BALTIMORE COUNTY PUBLIC SCHOOLS

ADDENDUM NUMBER _1_

BID NAME: NEW SCHOOL CONSTRUCTION LANSDOWNE ELEMENTARY
SCHOOL/DEMOLITION OF LANSDOWNE ELEMENTARY
SCHOOL__

BID NUMBER: **MBU-516-17**

SK-C-11

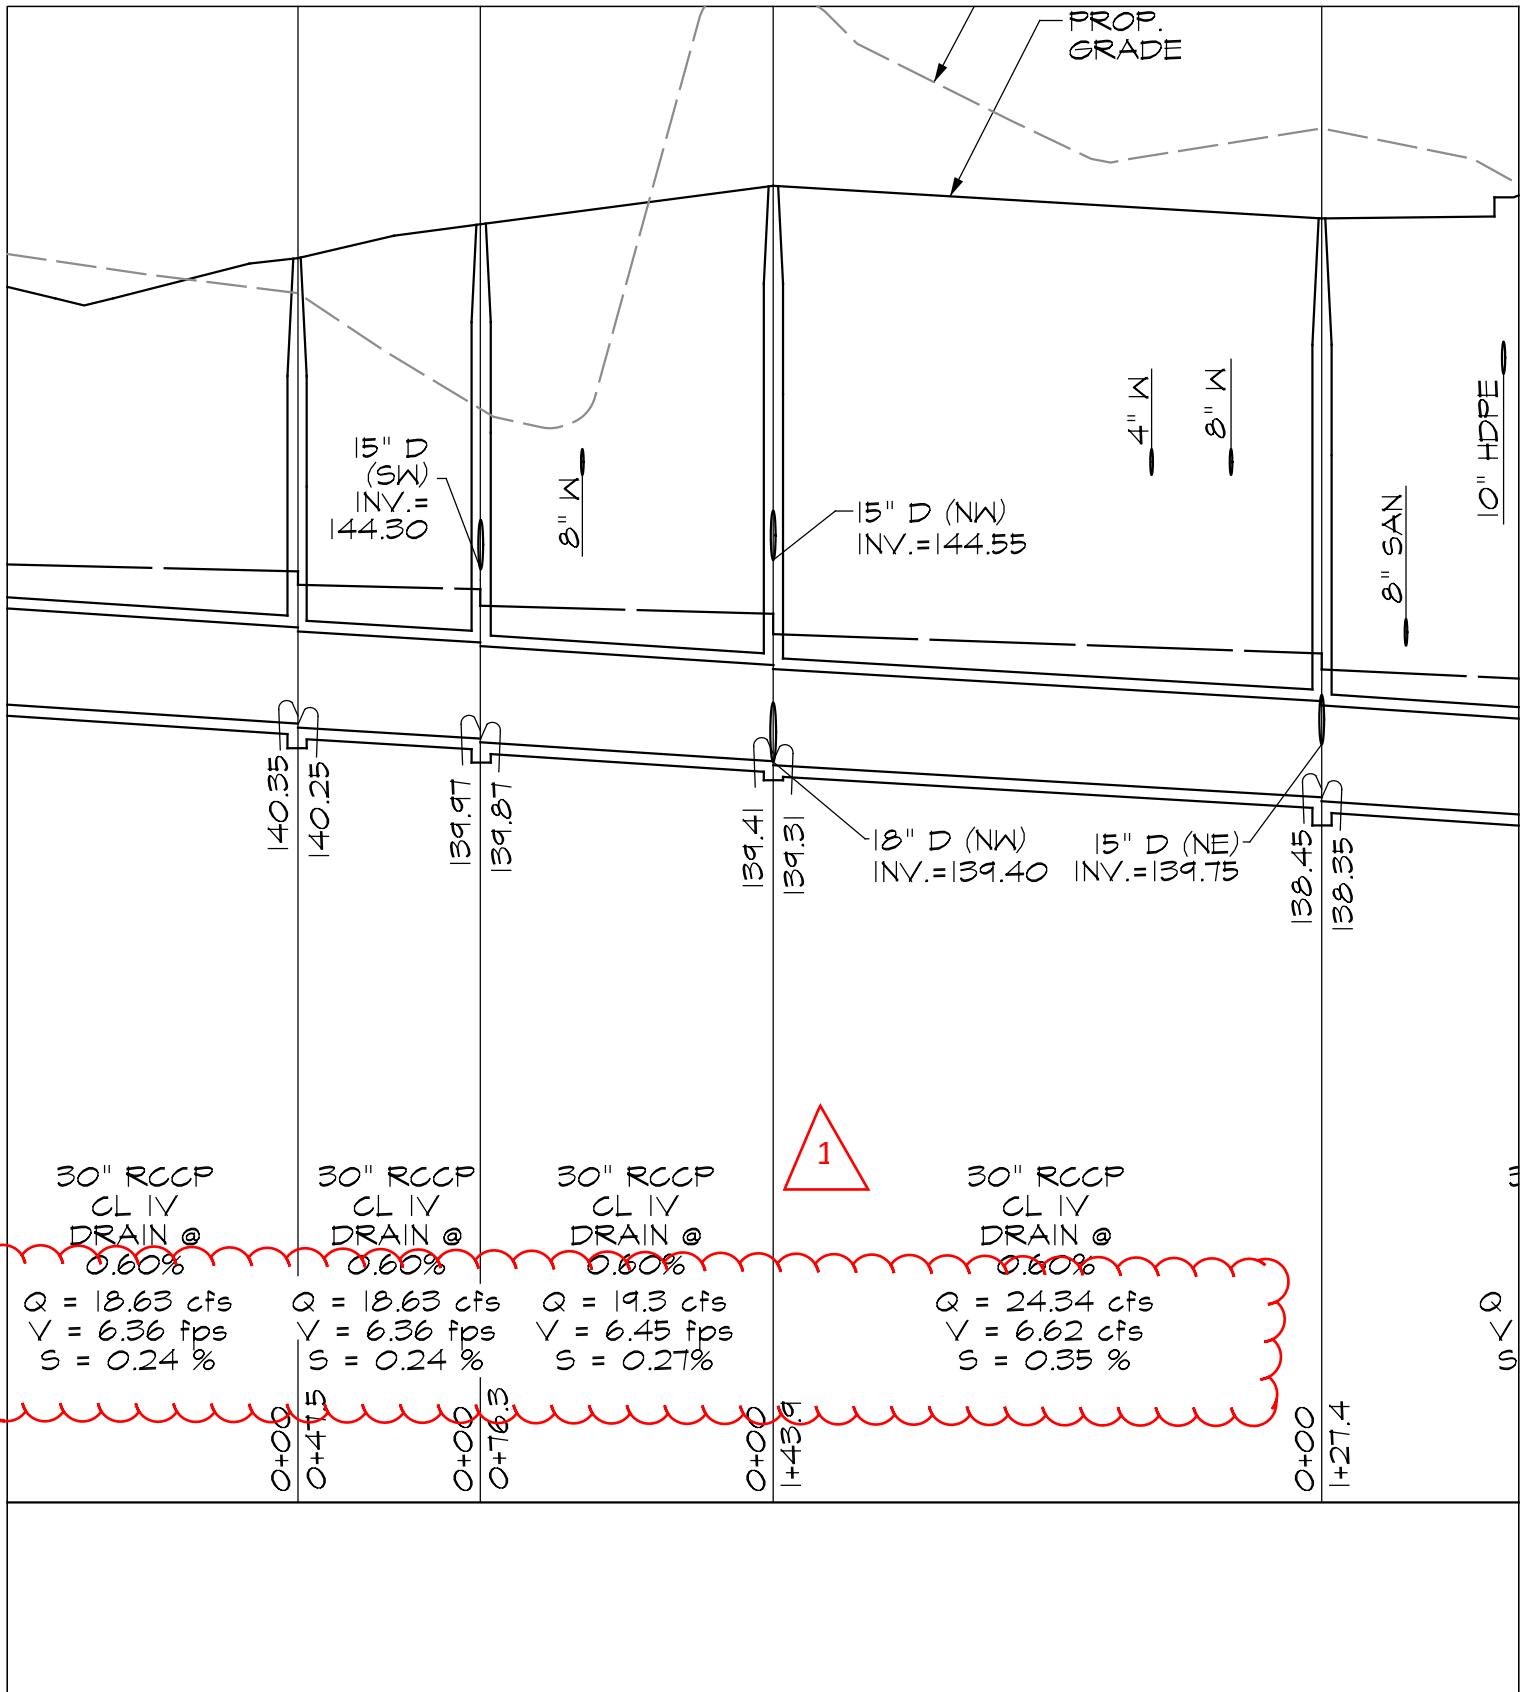
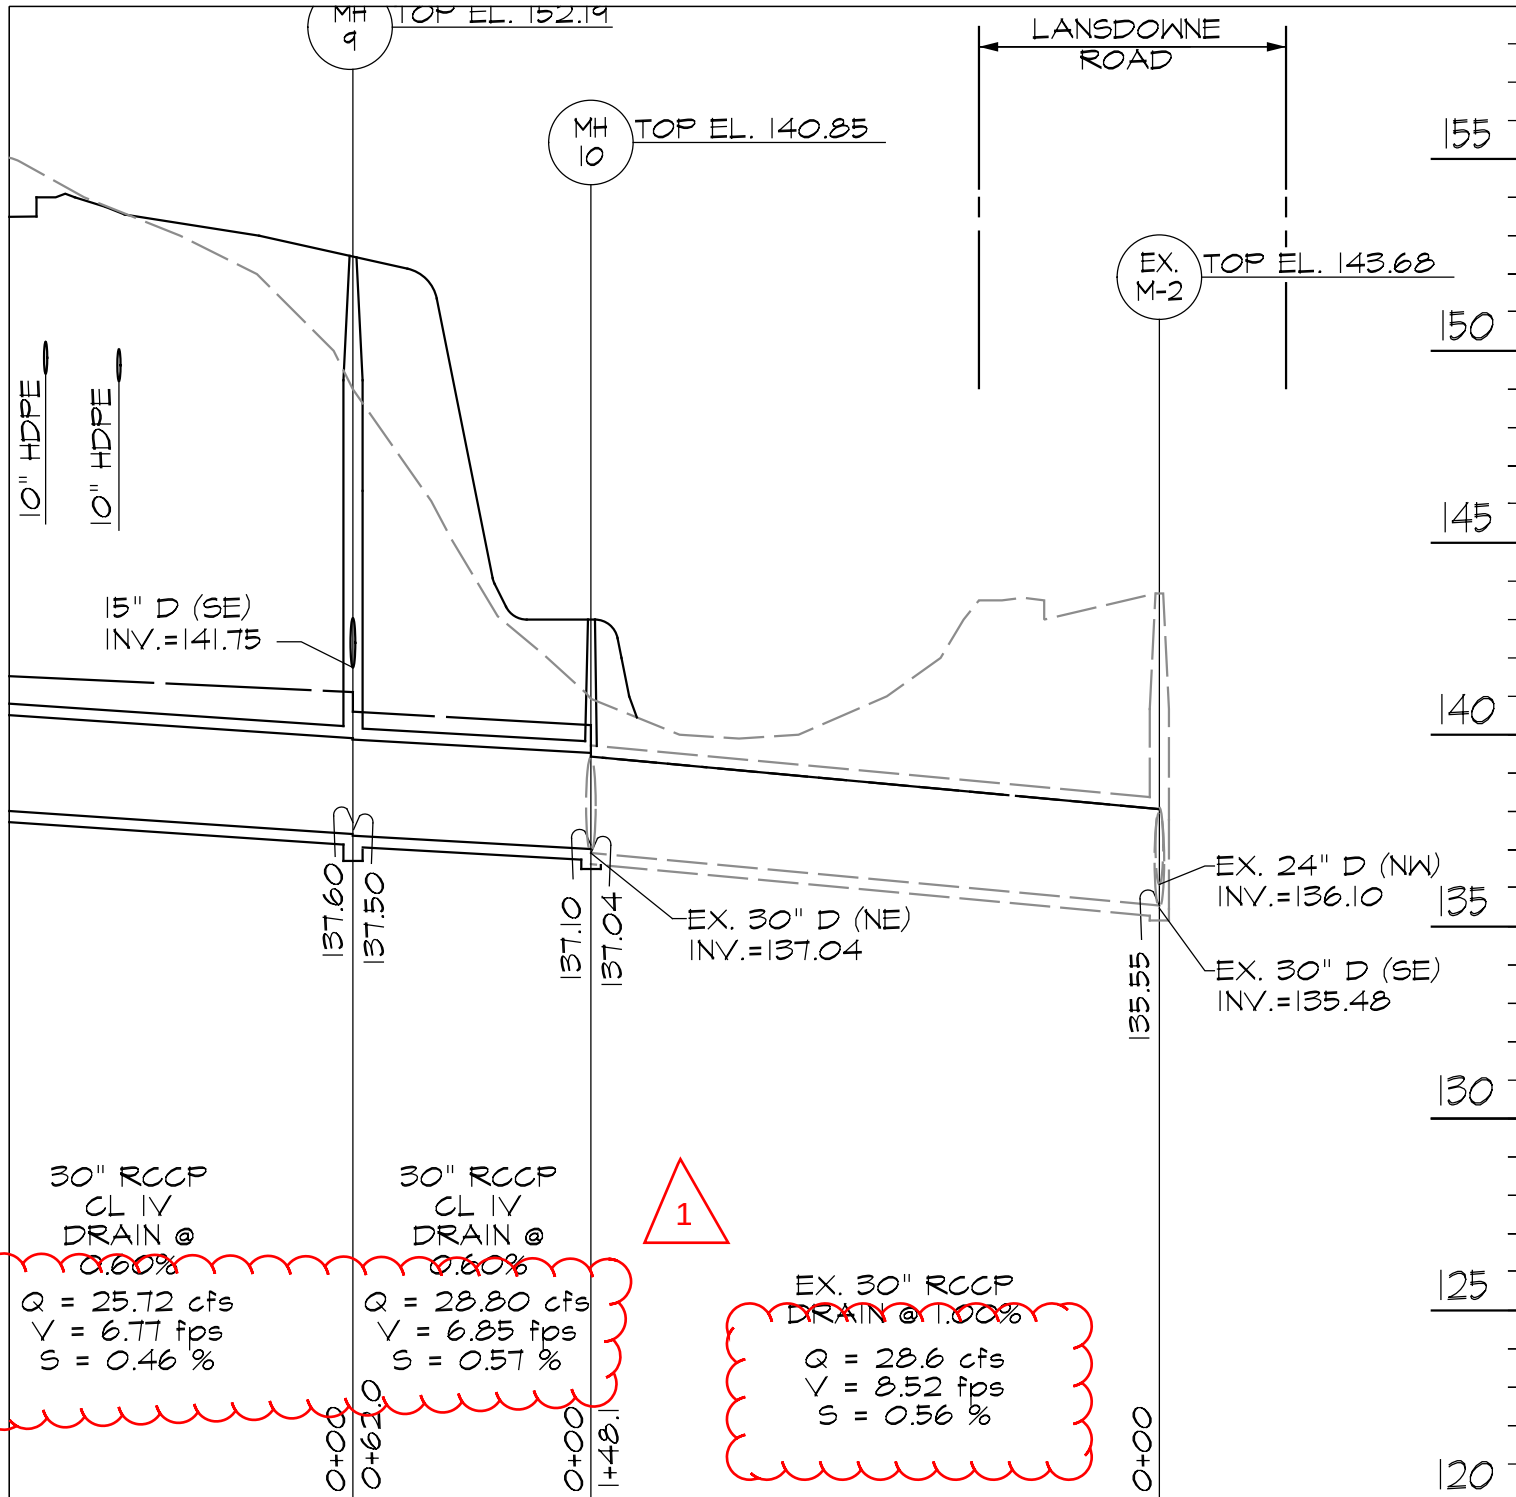
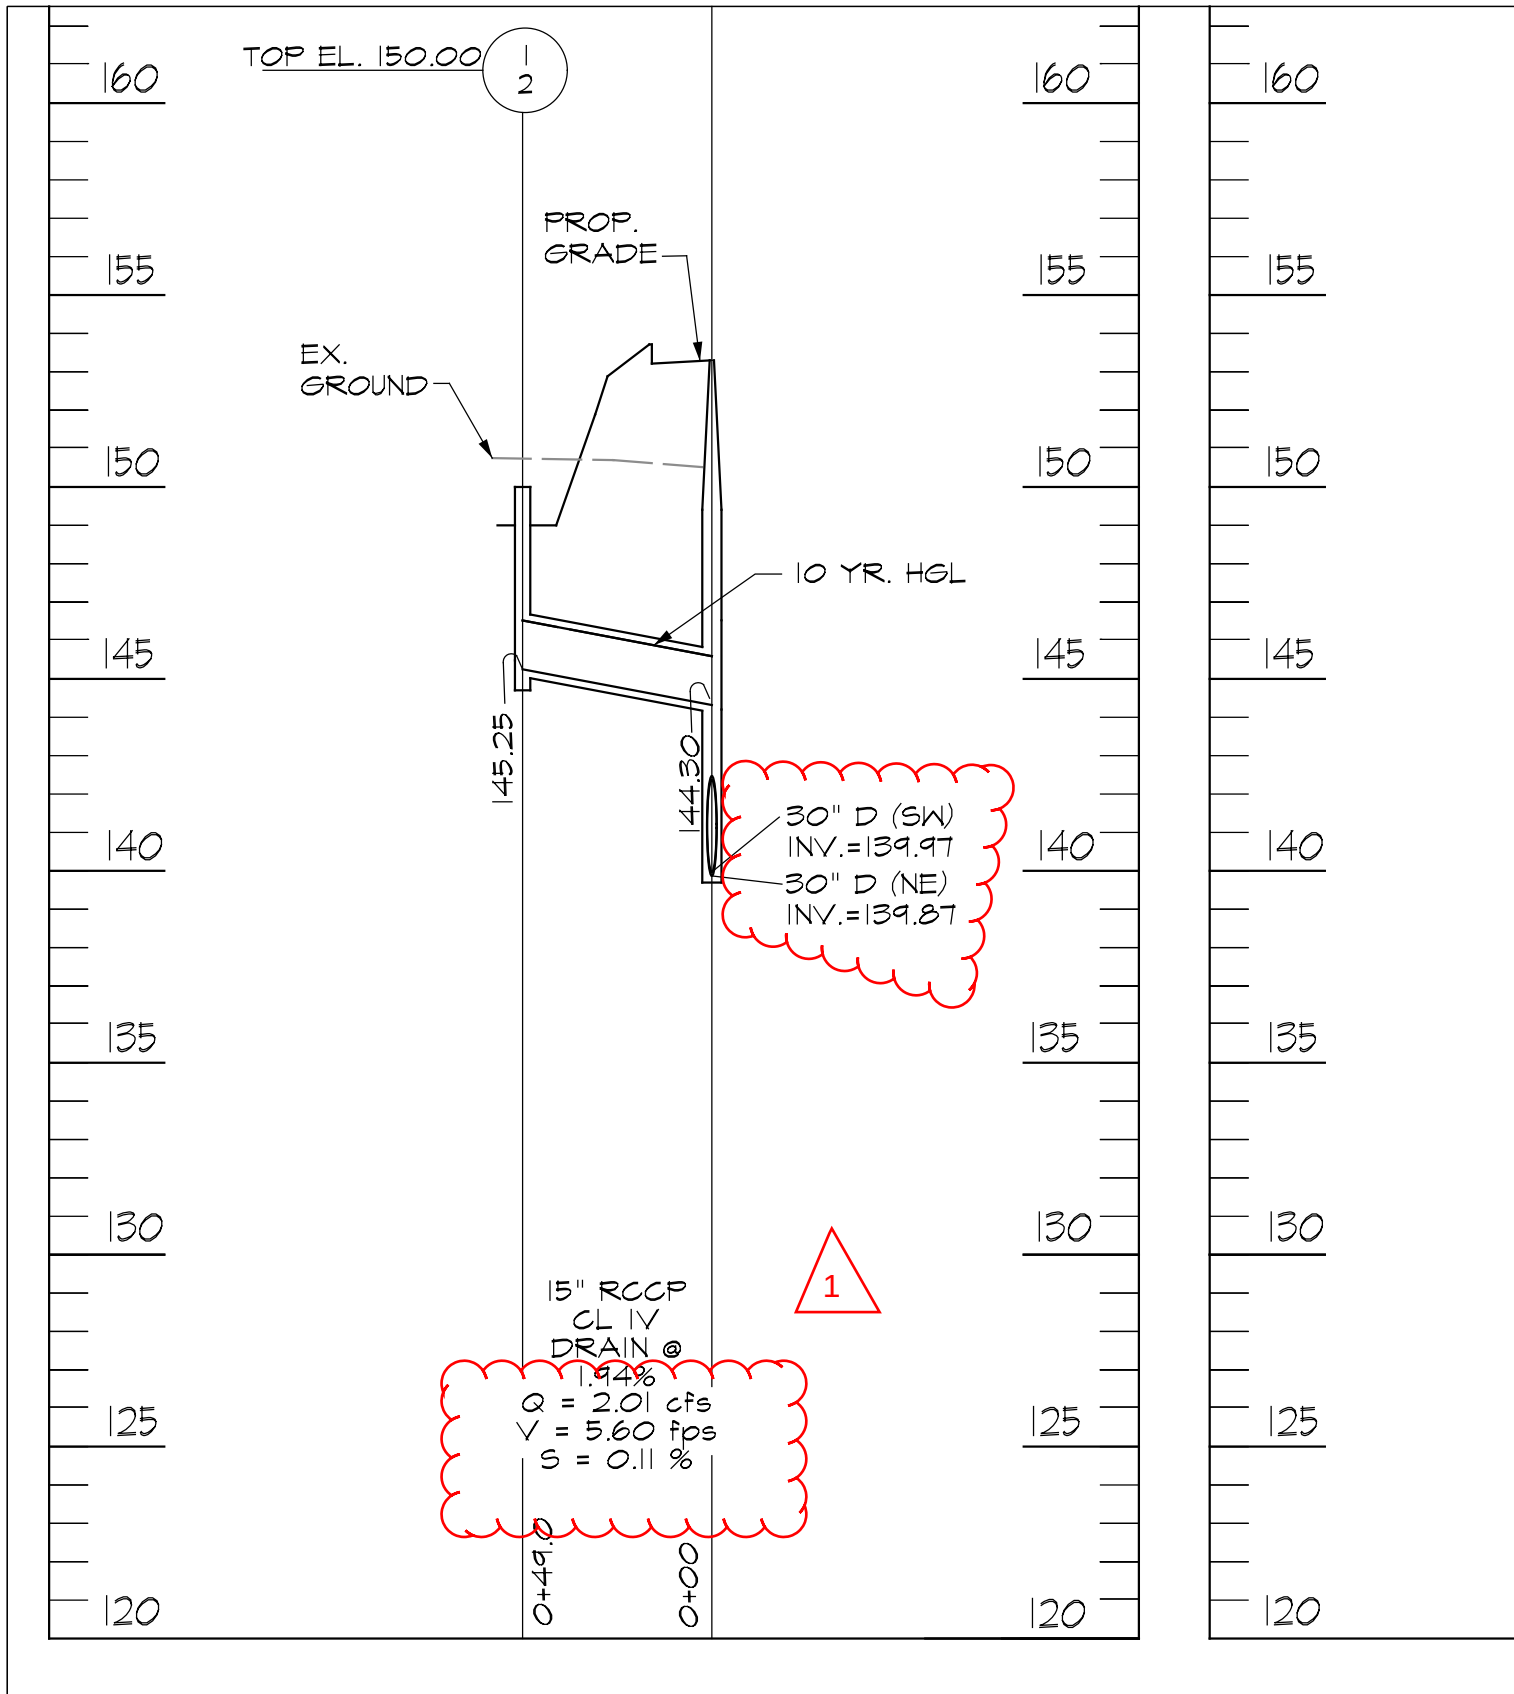
- 3.12. SHEET C-4.4, UTILITY PROFILES
REVISE: Storm Drain Profiles as indicated in attached sketches SK-C-11 – 11G.
- 3.13. SHEET C-4.5, UTILITY PROFILES
REVISE: Storm Drain Profiles as indicated in attached sketch SK-C-12 – 12E.
